CHARLES WILLIAMS STREAM, WETLAND, AND BUFFER SITE
EEP Project No. 80

MONITORING YEAR 2 (2014)
Construction Completed February 2013
Planting Completed February 2014

Response to EEP Comments – Draft MY2 Report

Subject: Response to Comments - DRAFT Annual Monitoring Report – Monitoring Year 2 (2014)
Sandy Creek (Charles Williams) Site Monitoring
Cape Fear River Basin – CU# 03030002
Randolph County, North Carolina
Contract No. 004682 – Task 5
EEP Project # 80

FIGURE 3b

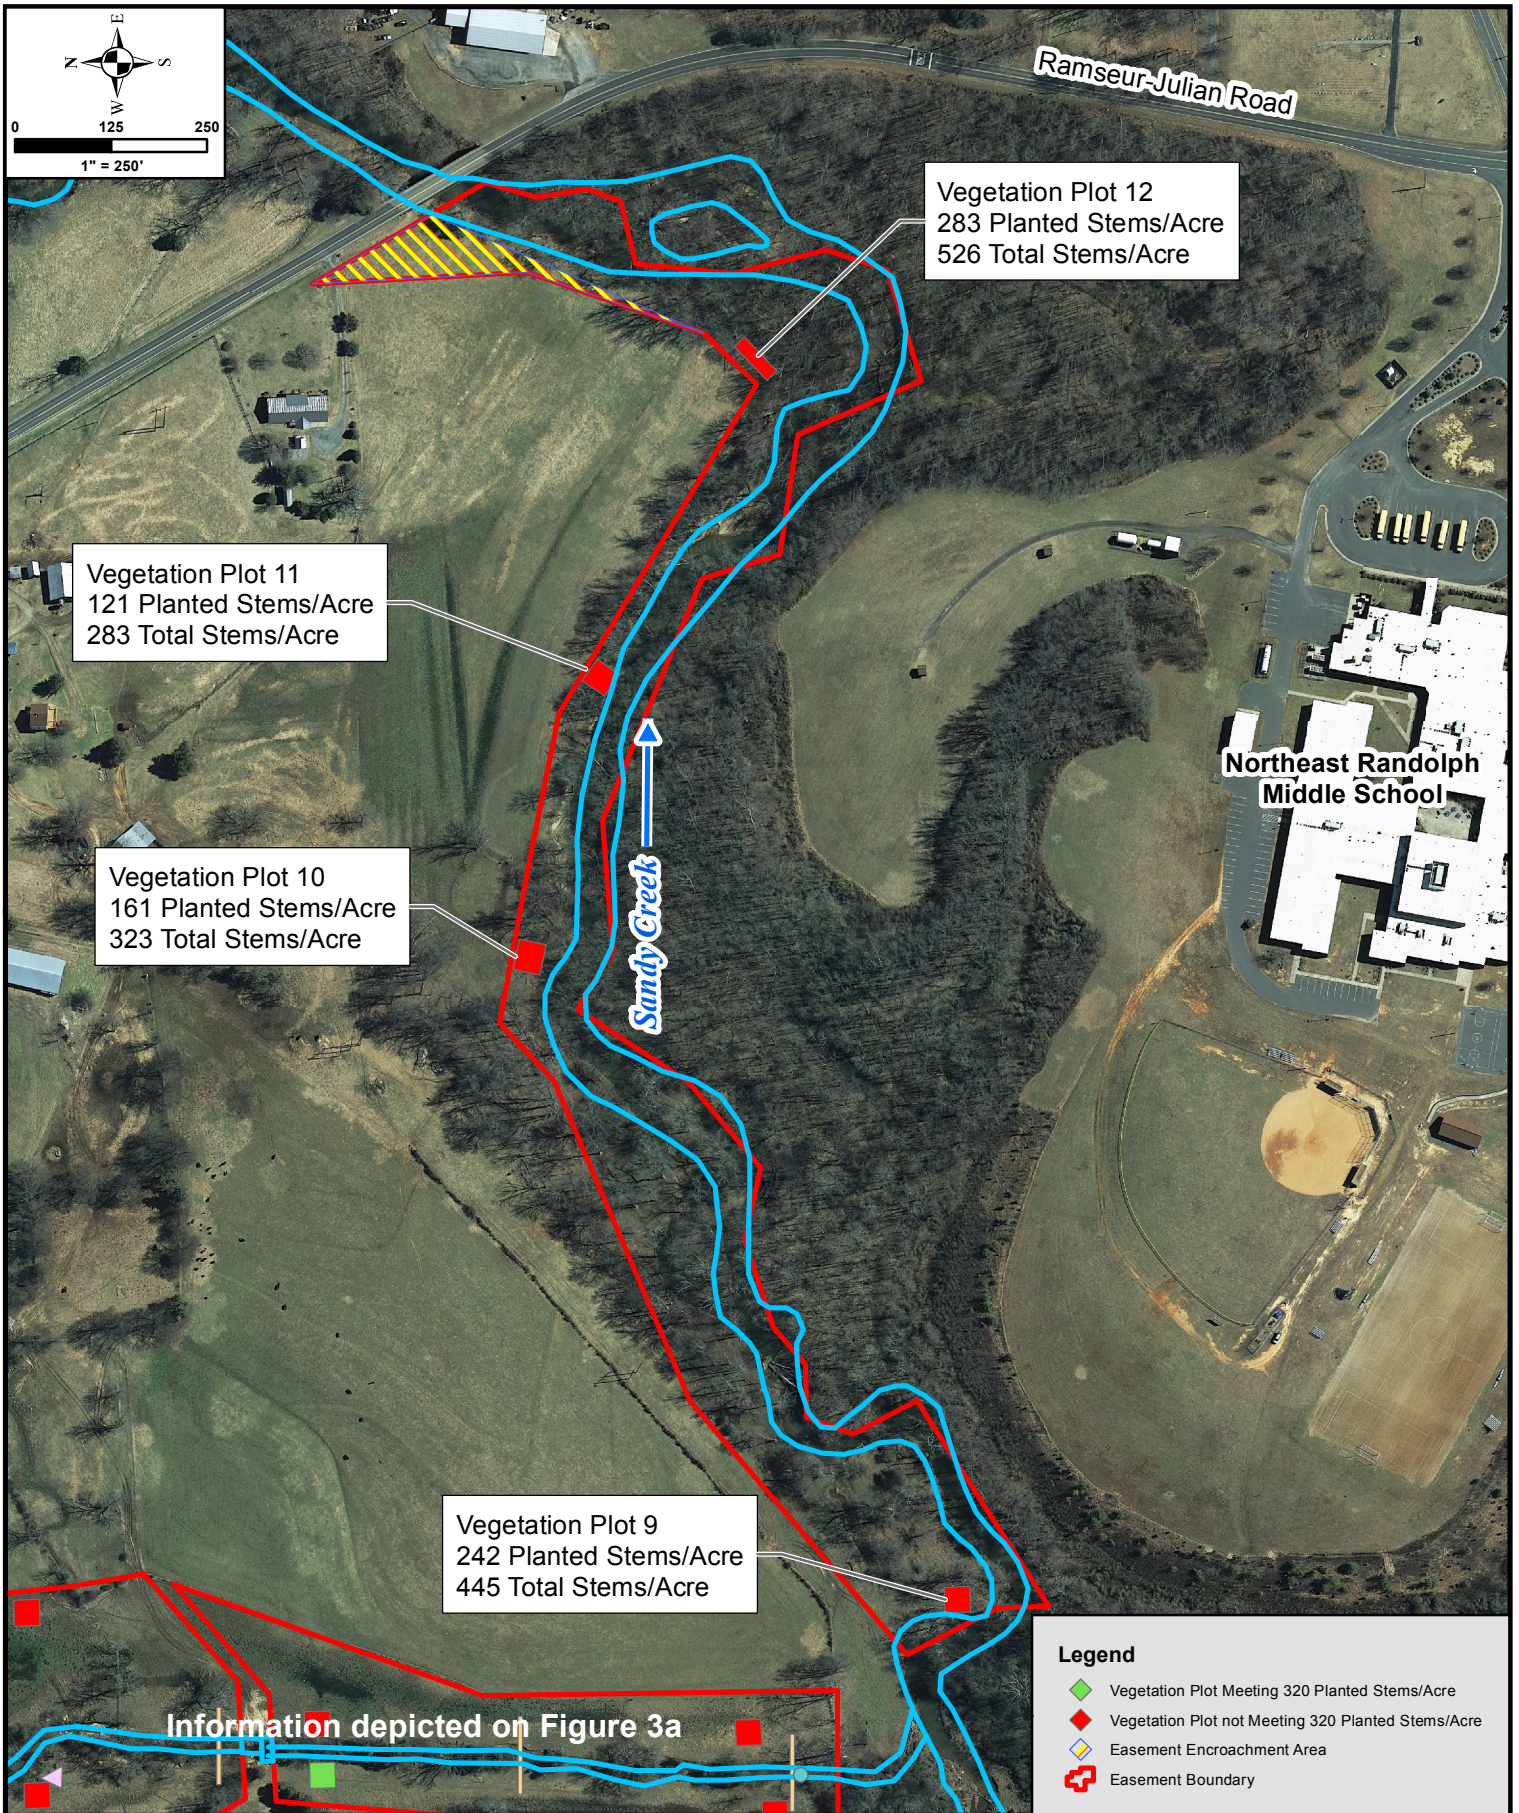
- **Comment: Please add the station numbers to the Plan Views.**
 - Response: We have added the station numbers to the Plan Views.
- **Comment: Figure 3b - Veg Plot #12 total stems/acre should read ~~536~~ 526.**
 - Response: We have corrected this typographic error on Figure 3b.
- **Comment: Please revise as necessary and provide 3 hardcopies and 1 pdf copy.**
 - Response: We will provide the requested revised MY2 report.

Profile Reach (UT Sandy Creek Sta. 10+00 to 17+53)

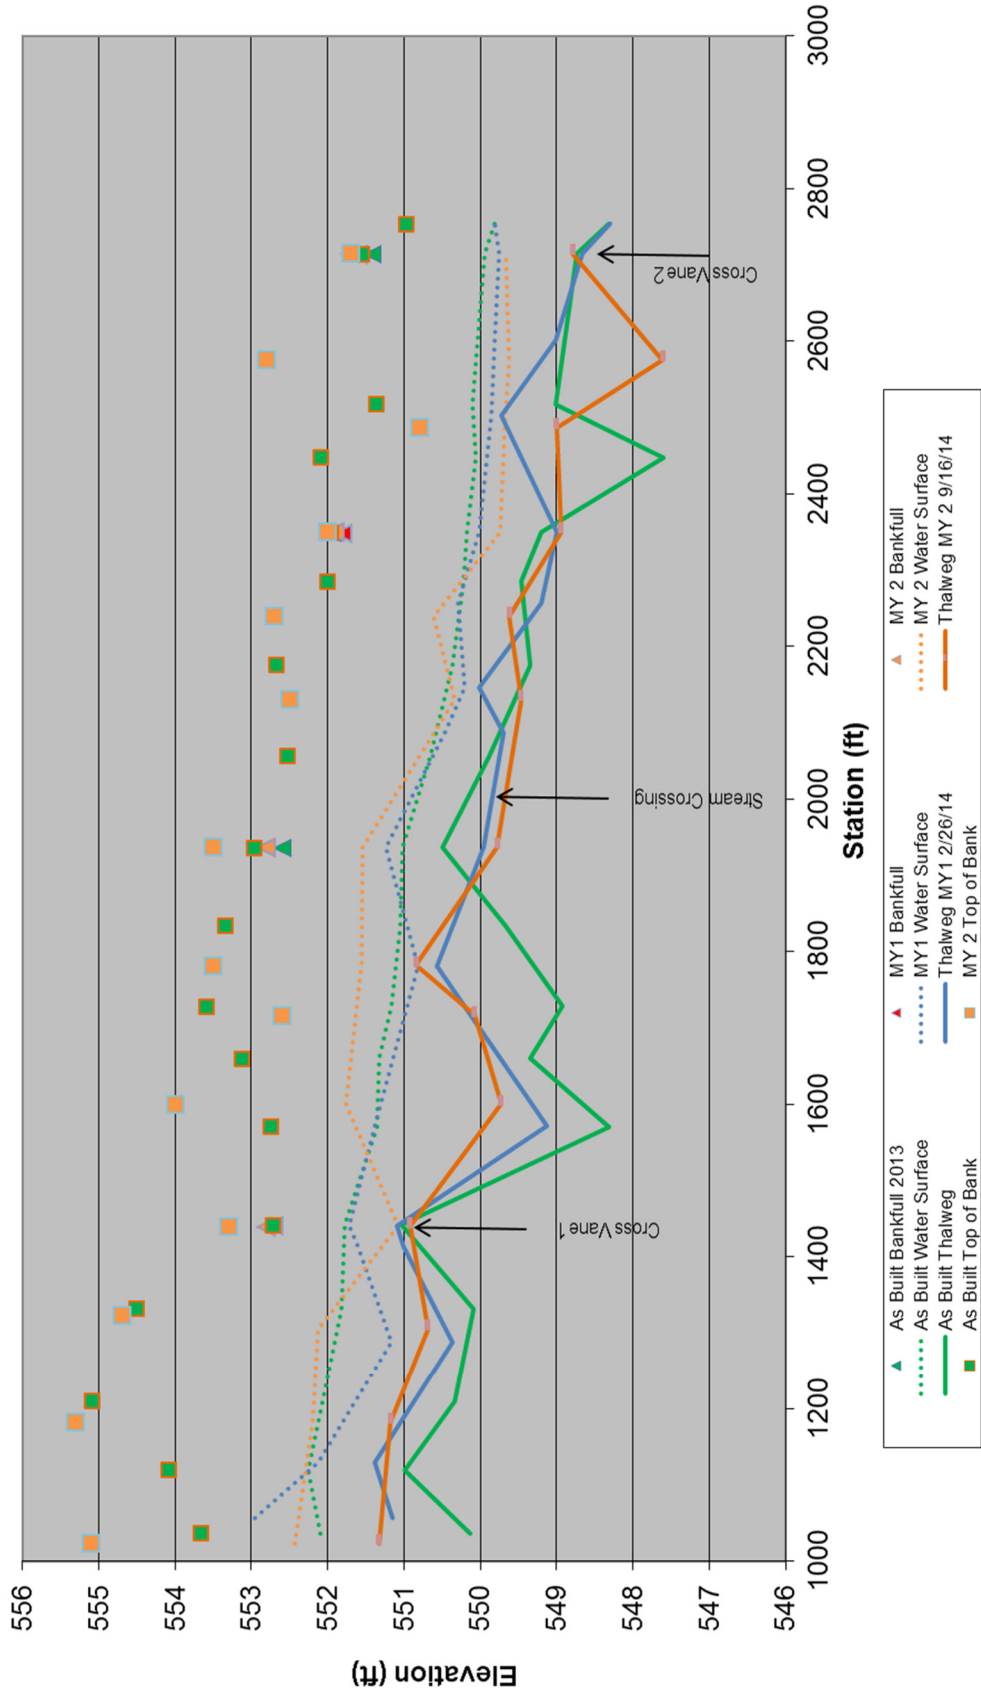
- ***Comment: The Profile Reach data between Station 2300 and 2700 appears incorrect. Please confirm.***
 - ***Response:*** A comparison of As-built, MY1, and MY2 longitudinal profile charts does indeed show what appears to be incorrect data. Specifically, As-built data show a pool at station 2447, MY1 data show no pool in this area, and MY2 data show a pool at station 2575.

To determine the cause of this data representation, the raw point files were opened in Microstation and viewed in plan view. Longitudinal profile data shots were observed to be spaced widely apart and inconsistent in location between subsequent monitoring years. Due to the lack of detailed data collection, it is currently not possible to determine the actual longitudinal profile of the stream. There may be a single pool migrating downstream, or it is also possible that different pools were captured between As-built and MY2 data collection and the pools were completely missed during MY1. Because data points were not taken in the same spots, we cannot currently assess which of these possibilities is correct.

To improve the accuracy of subsequent longitudinal profile charts, greater detail will be collected in the field. An effort will be made to capture grade breaks (including individual pools and riffles) at more closely spaced intervals than have been captured in the past.
